PLANNING AND ZONING COMMISSION ACTION ITEM STAFF SUMMARY MAY 6TH, 2020 PLANNING AND ZONING COMMISSION MEETING

Consideration of Resolution No. PZ 05-20, Series of 2020. A RESOLUTION RECOMMENDING APPROVAL OF A MAJOR PUD AMENDMENT FOR THE DILLON URGENT CARE & RESIDENCES PUD DEVELOPMENT PLAN LOCATED AT 956 W. ANEMONE TRAIL. (PUBLIC HEARING)

Major PUD Amendment to
Dillon Urgent Care and Residences
PUD Development Plan

PUD (PLANNED UNIT DEVELOPMENT) PERMIT Sheet Title SITE PLAN

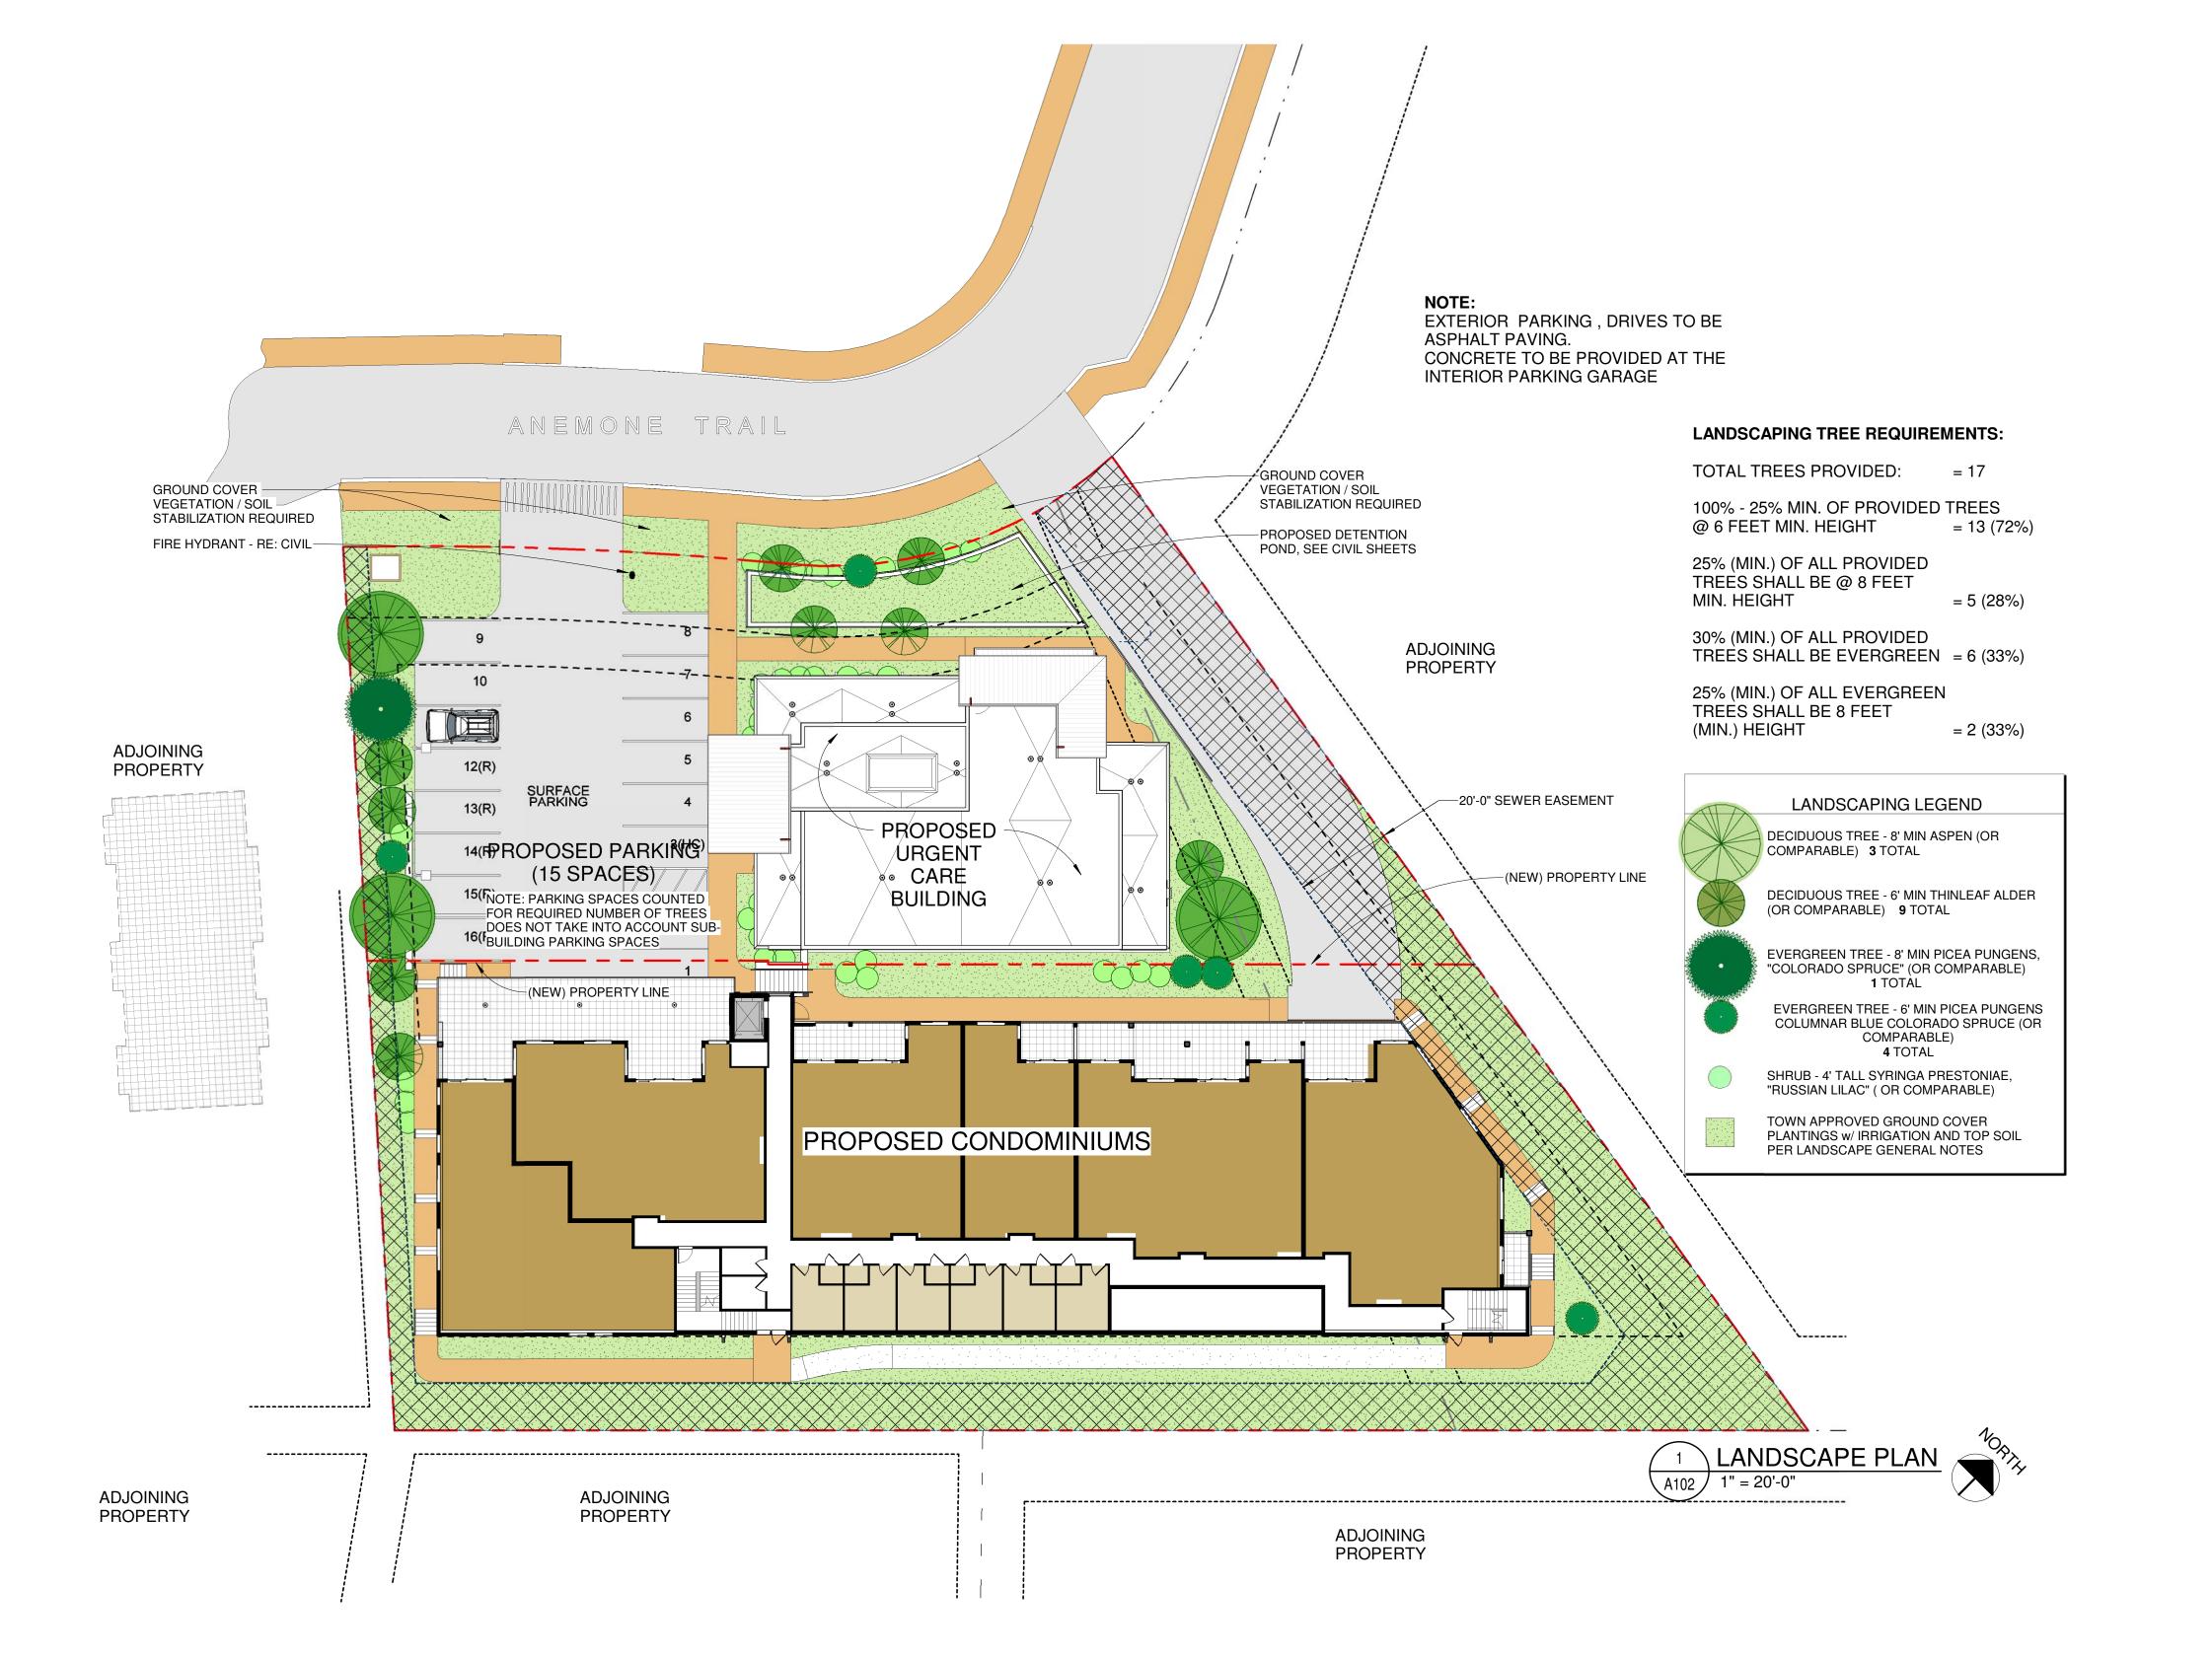
The main change to the site was adding a second driveway to the east end of the condominium building, along the eastern property line adjacent to the Dillon Dam Brewery development. The residential building garage level is now 5.5' above the finished floor elevation of the clinic, which made access through the clinic parking lot not possible. The new 20' driveway will be constructed within the 25' wide sanitary sewer easement located along this property line. From a sanitary sewer maintenance, grading, and access standpoint, this arrangement is desirable to the Town.

This new driveway shifted the clinic building and the commercial parking lot about 6 feet to the west. The parking lot is still outside the utility easement on the west side, and some trees are also proposed to screen the parking lot from the townhome complex along the west side of the street.

Lot 45A: The commercial parking lot was expanded to include one additional space for a total of 16 spaces. The 3,649 gross square foot clinic building requires 10 parking spaces at a rate of 1 parking space per 400 square feet. The three studio apartments require 1.5 parking spaces per unit, for a total of 5 parking spaces. A total of 15 parking spaces are required on lot 45A. Sixteen parking spaces are providing on Lot 45A, creating one additional parking space above the code requirement.

17039 Job Number: 2018 NOV 14 Drawn By: Checked By: Project Phase PUD (PLANNED UNIT DEVELOPMENT) PERMIT Sheet Title **SNOW STORAGE** Sheet Number

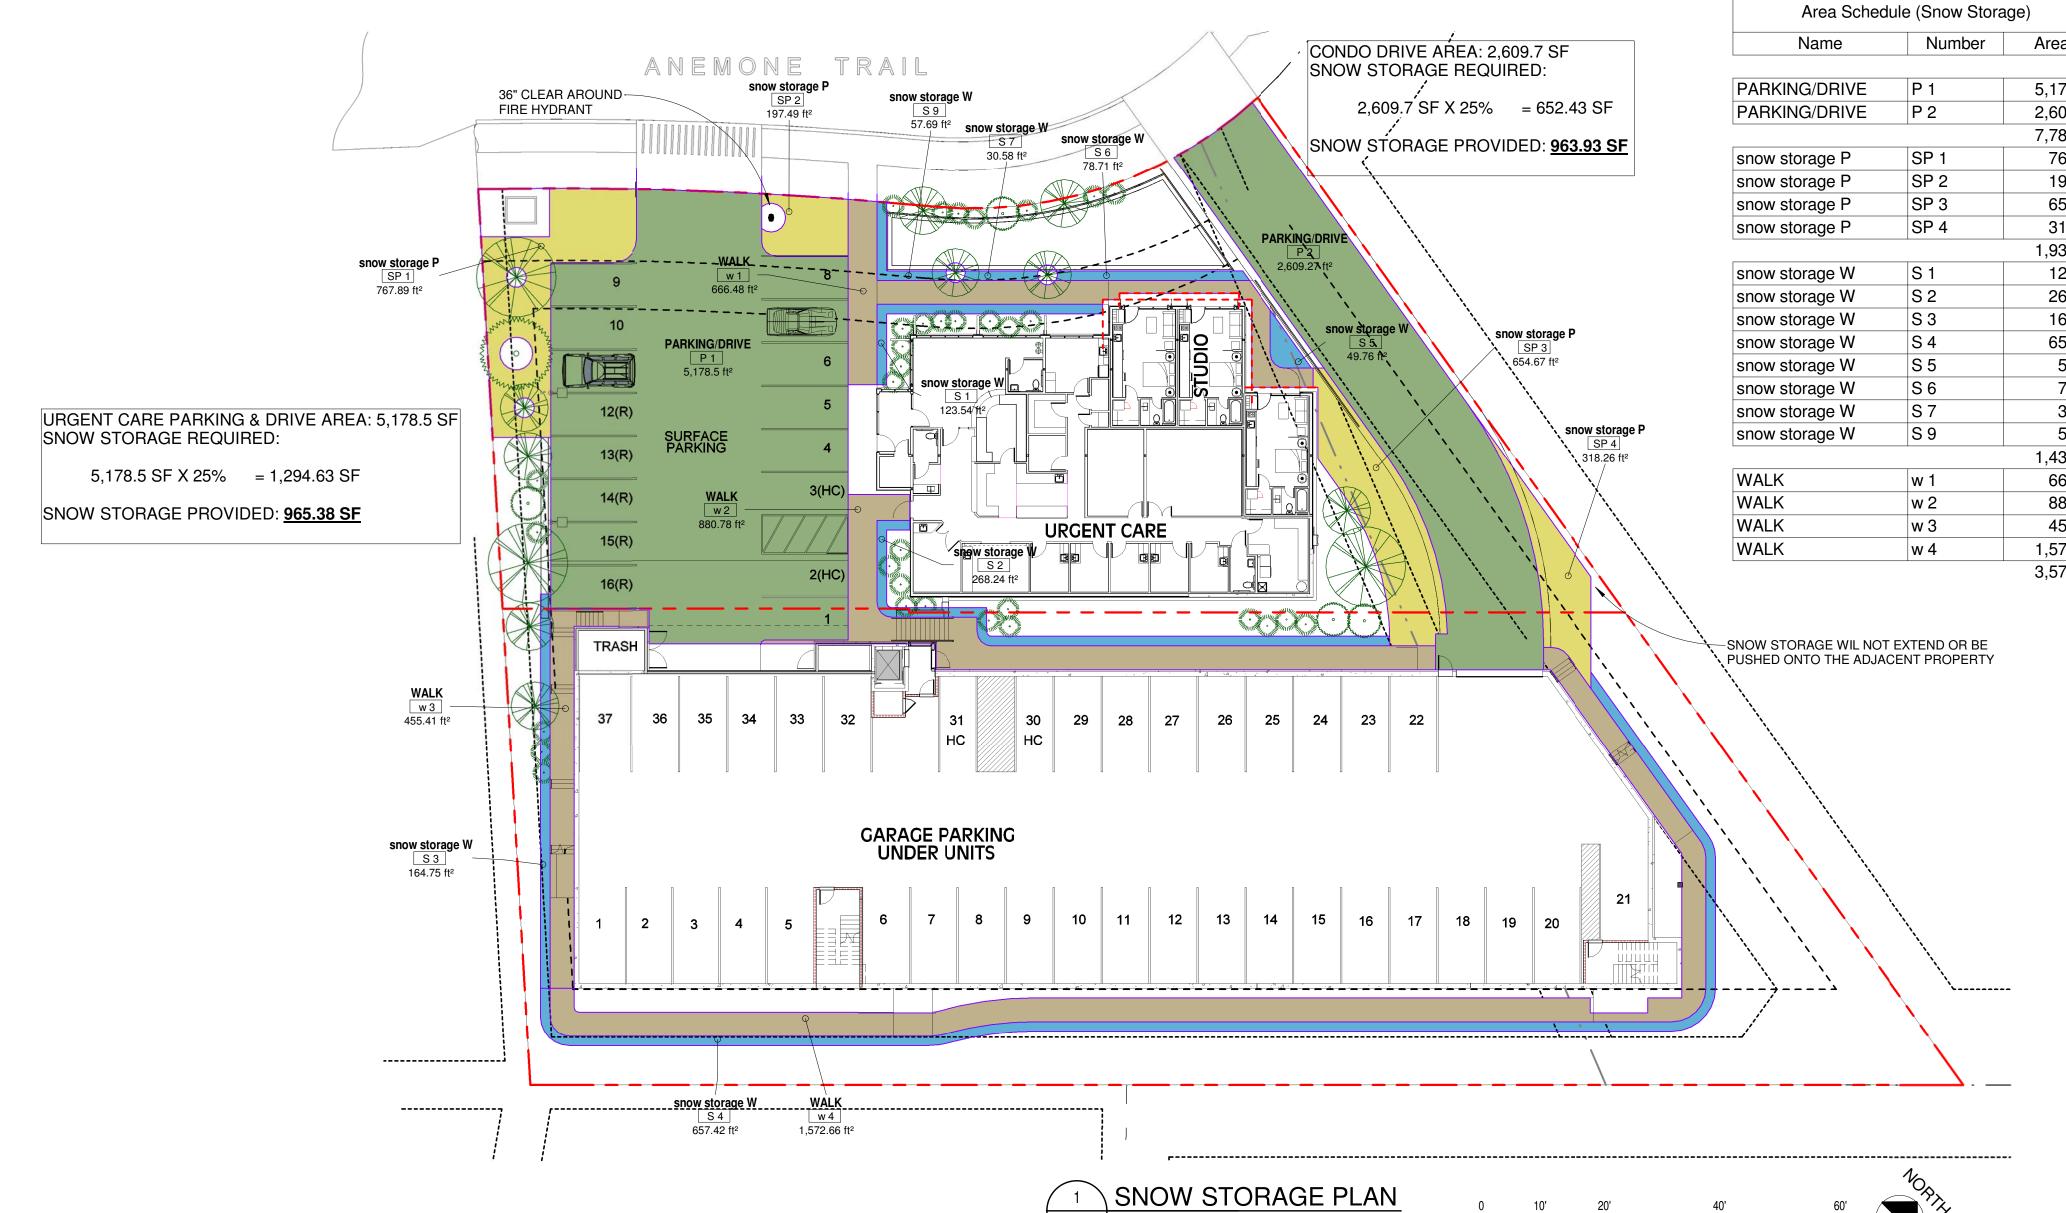
The PUD provides the required 25% of snow storage for the residential driveway, parking lots and sidewalks. However, due to the tight nature of this site and conflicts with landscaping within the proposed snow storage areas, the PUD will require the Developer to haul off snow from the site once the snow storage areas are full. See Sheet A104 for more specific details.
